From: Dave Kubeczko - DNR
Sent: Monday, May 09, 2016 9:13 AM
To: Dave Kubeczko
Subject: Anderson C2 and C3 Info

ENGINEERING AND SITING INFORMATION

Summary of Location Assessment Activity for Anderson C2 and C3 Well Pad

ANDERSON C 2 & 3
 SPACING UNIT

Max. Inclination v. Average of Pump Failures/Year

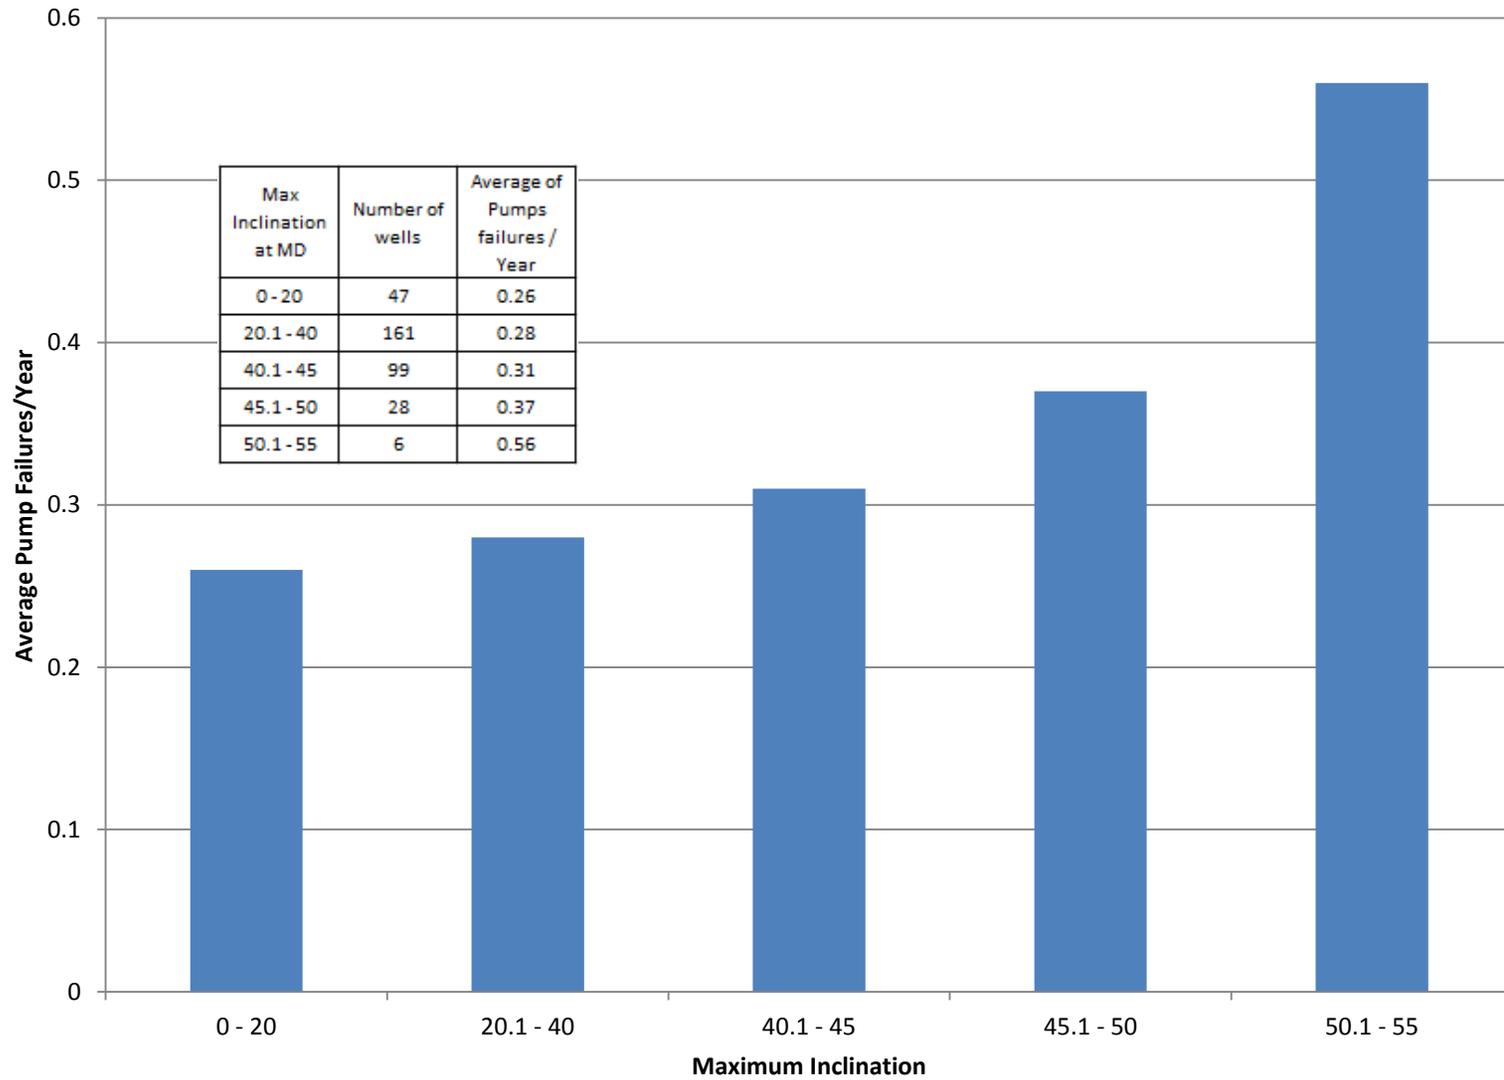
What are the *specific technical reasons* these wells *cannot be drilled* in other locations to meet the surface setback rules? The information in your variance request is *insufficient* for just cause to authorize and approve the request. I would prefer speaking with BP's drilling engineer and if BP deems it necessary, anyone else pertinent to sharing information and making final decisions & approvals.

My experience has been that these wells *can be drilled* from various other locations, but could be more difficult, risky and costly. Also, the sharper the twist and turns are in the wellbore along with a greater angled wellbore (approaching horizontal) usually creates more wear and tear on rods, pumps, and tubing which increases monthly operating costs. In this case, these wells will be started vertically then a build and hold (constant angle) to TD. If these are indeed the reasons for not drilling in other various locations, then the engineers must so state and provide specific reasons and justifications and proof. I would prefer written explanations to follow my verbal conversation. BTW, this may and even likely require specific in house and performance data from your records.

Our experience indicates Fruitland coal wells which are deviated beyond 40 degrees typically have higher operating costs due to increased rod pump equipment failure frequency and increased maintenance requirements. These design limits are supported by the attached graph which summarizes an analysis of 398 BP operated wells. This analysis shows failures occur, on average, once every 3.8 years for wells where maximum deviation is limited to 20 degrees or less. The failure rate continues to increase as maximum deviation is increased, with a failure occurring, on average, every 3.2 years for wells with a maximum deviation between 40.1 and 45 degrees. It should also be noted there are very few wells with maximum deviations of more than 55 degrees in the data set. These highly deviated wells were excluded from the analysis because these designs typically involve horizontal laterals with a pump placed in the vertical section or in a pilot hole, and they exhibit failure rates similar to those of less deviated wells.
